SUBJECT: ISSUANCE OF AMENDMENT NO. 178 TO FACILITY OPERATING LICENSE
NO. NPF-6 - ARKANSAS NUCLEAR ONE, UNIT NO. 2 (TAC NO. M96478)

ATTACHMENT TO LICENSE AMENDMENT NO. 178

SAFETY EVALUATION BY THE OFFICE OF NUCLEAR REACTOR REGULATION
RELATED TO AMENDMENT NO. 178 TO
FACILITY OPERATING LICENSE NO. NPF-6
ENERGY OPERATIONS, INC.
ARKANSAS NUCLEAR ONE, UNIT NO. 2
DOCKET NO. 50-368

FIGURE 3.9.2
 MINIMUM BURNUP VS. INITIAL ASSEMBLY AVERAGE U-235 LOADING

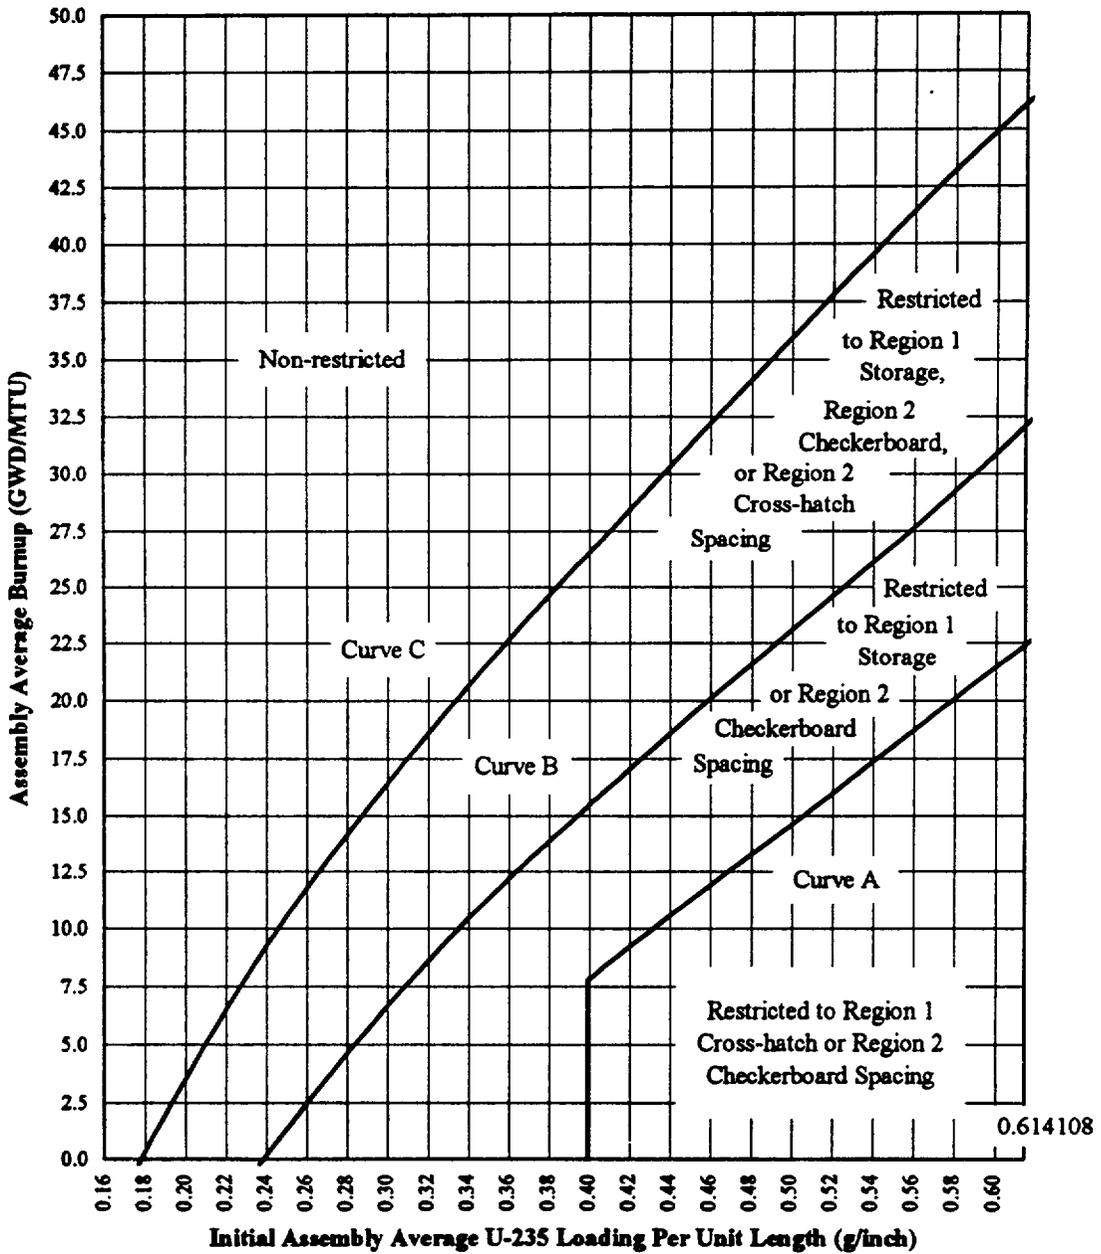
For Configurations B and C in Region 2, credit for assembly burnup is used to allow storage of assemblies enriched to 5.0 w/o U-235. In Configuration B, fuel assemblies meeting the Configuration B burnup versus initial U-235 loading curve shown in TS Figure 3.9.2 can either be stored adjacent to two water holes or in diagonal locations from the four water holes. The calculated 95/95 k_{eff} value for Configuration B is 0.944.

For Configuration C in Region 2, any assembly meeting the burnup requirements shown in TS Figure 3.9.2 may be stored in any Region 2 rack location. The 95/95 k_{eff} value is 0.9498.

- 1) TS 3.9.12.a is being revised to allow fuel assemblies containing enrichments of up to 5.0 w/o U-235 to be stored in the spent fuel pool.
- 2) TS 3.9.12.b and Figure 3.9.2 are being revised to provide alternate storage configurations in the spent fuel pool in order to accommodate the higher enrichment fuel.
- 3) TS 5.6.1.2 is being revised to allow fuel assemblies containing a maximum U-235 enrichment of up to 5.0 w/o to be stored in the fresh fuel storage racks.

4.9.12.b Verify all fuel assemblies to be placed in the spent fuel pool are within the limits of Figure 3.9.2 by checking the assemblies' design and burnup documentation.
